UPPER UWCHLAN TOWNSHIP  
PLANNING COMMISSION  
**REVISED** AGENDA  
**May 12, 2022**

Reference: Parcel 5C (Byers Station) – Lot 2B  
Amended Final PRD Plans – First Review  
Upper Uwchlan Township, Chester County, PA

Re:      Final Land Development - Byers Station Amended Final PRD Plan for Lot 2B of Parcel 5C  
#      Upper Uwchlan Township - LD-03-22-17149

***Detail of Byers Station Amended Final PRD Plan for Lot 2B of Parcel 5C  
Final Land Development Plan***

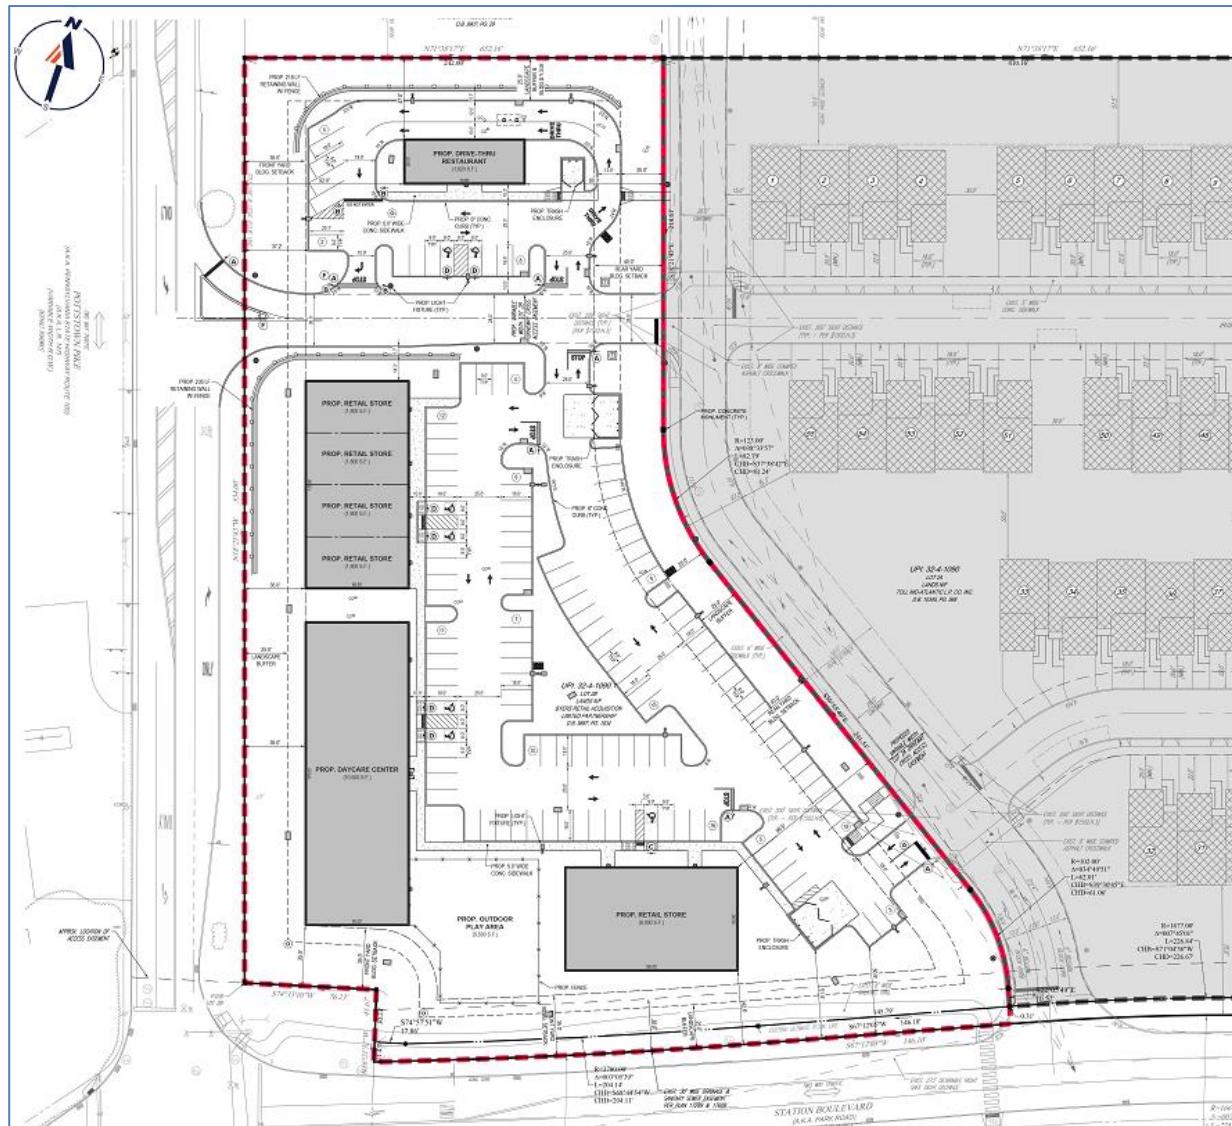
4. The County Planning Commission's Multimodal Circulation Handbook (2016 Update), which is available online at [www.chescoplanning.org/resources/PubsTransportation.cfm](http://www.chescoplanning.org/resources/PubsTransportation.cfm), classifies Pottstown Pike (State Route 100) as a Major Arterial roadway. The Handbook (page 183) recommends a 150-foot-wide right-of-way for Major Arterial roads to accommodate future road and infrastructure improvements. We recommend that the applicant and the Township contact

5. The Township Engineer should review the intersection at Pottstown Pike and Station Boulevard to determine whether a merging lane may be needed at the exit nearest the drive-through restaurant and turning right onto Pottstown Pike. Due to the size of this proposal and its location, we suggest that the Township's review of this submission would benefit from the preparation of a current traffic impact study and a review of the potential impacts posed by this project.

6. Pedestrian connectivity between sidewalks and buildings is an important component of a complete sidewalk system in the **Suburban Center Landscape**. "Connect" Objective C of *Landscapes3*, the 2018 County Comprehensive Plan, is to provide universally accessible sidewalks, trails, and public transit connections to create a continuous active transportation network within designated growth areas. We encourage the applicant to provide appropriate sidewalk connections from this site to the adjacent residential areas. The applicant should contact the owner of the residential area to the north to provide a potential pedestrian connection to this site.

7. The commercial buildings appear to be oriented inwards towards the site, with their rear and side elevations facing Pottstown Pike and Station Boulevard. Few stores in the Eagle village area present their rear elevations to Pottstown Pike and Station Boulevard. While the applicant has provided landscaping along Pottstown Pike and Station Boulevard in these areas, we recommend that the applicant and the Township carefully consider how the designs of the rear elevations will appear as viewed from the public rights-of-way of the adjacent roadways, and how they will fit within the context of the area. Blank walls should be avoided, and variations in textures and materials should be considered. Optimally, windows should also face the roadways. We also suggest that the applicant avoid the use of flat roofs on the structures, because many of the nearby structures have pitched roofs. The Township should ask the applicant for conceptual architectural renderings to illustrate these design issues.
